# Access Compliance Report

## Public Rights-of-Way

### (Curb Ramps)

Intersection ID: 8213	Main Street: LYLES_CT	Cross Street: SPRINGVIEW_RD	Location: SE
ADA ID: 3BAFD5C049B9	Ramp Type: Perp	Initial Pass/Fail: Fail	Overall Compliance: No
			Severity Score: 46.25

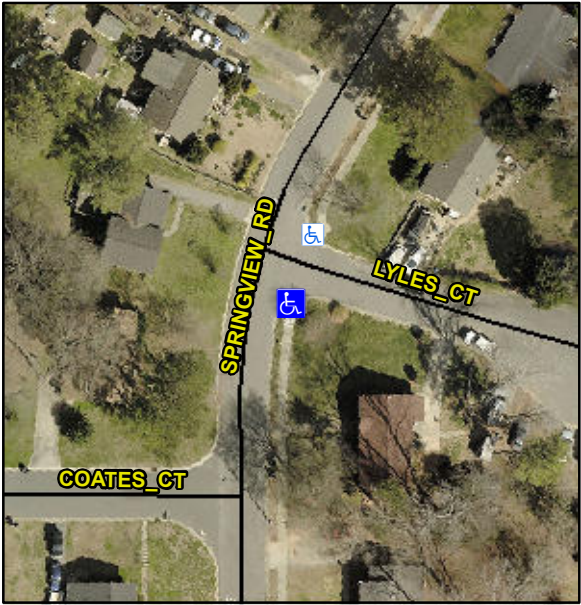
Codes/Mitigation Info/Possible Solution			Field Measurements/Component Compliance		
	Possible Solutions:		<b>Compliance</b>	<b>Description</b>	<b>Data</b>
	<b>Remove &amp; Replace Entire Ramp.</b>		<b>No</b>	Ramp Length (in)	26.0
			<b>No</b>	Ramp Width (in)	43.0
			<b>N/A</b>	Flare Type LT	N/A
			<b>N/A</b>	Flare Slope LT (%)	N/A
			<b>N/A</b>	Flare Traversable LT?	N/A
			<b>N/A</b>	Landing Length (in)	N/A
			<b>N/A</b>	Landing Width (in)	N/A
			<b>N/A</b>	Landing Slope (%)	N/A
			<b>N/A</b>	Landing X Slope (%)	N/A
<p>Surveyor Notes:</p> <p><b>N/A</b></p> <p>PROW/ADA:</p> <p><b>Not Found, R304.5.1, R304.2.2, R304.5.3</b></p>			<b>N/A</b>	Flare Type RT	N/A
			<b>N/A</b>	Flare Slope RT (%)	N/A
			<b>N/A</b>	Flare Traversable RT?	N/A
			<b>N/A</b>	DWS Provided?	N/A
			<b>N/A</b>	DWS Contrast?	N/A
			<b>N/A</b>	DWS Length (in)	N/A
			<b>N/A</b>	DWS Full Width?	N/A
			<b>N/A</b>	DWS Offset (in)	N/A
			<b>N/A</b>	Gutter Ponding?	N/A

<b>N/A</b>	Gutter Lip Ht (in)	1.5
			<b>No</b>	Painted X Walk1?	N/A
				X Walk 1 Direction	To N
			<b>N/A</b>	X Walk 1 Width (in)	N/A
				X Walk 1 Slope (%)	3.5
				X Walk 1 X Slope (%)	5.3
			<b>N/A</b>	Ramp inside XWalk1?	N/A
			<b>N/A</b>	Road Slope (%)	N/A
			<b>N/A</b>	Road X Slope (%)	N/A
			<b>N/A</b>	Any Obstructions?	N/A
				Obstruction Type	
Total Cost:					
		\$ 1850.00			
			<b>N/A</b>	Clear Space?	N/A
			<b>N/A</b>	Clear Space to XWalk (in)	N/A
			<b>N/A</b>	Storm Grate/Utility Hazard?	N/A
				Storm Grate/Utility Type	
			<b>N/A</b>		N/A
			<b>Yes</b>	Surface Condition? (G/P)	Good
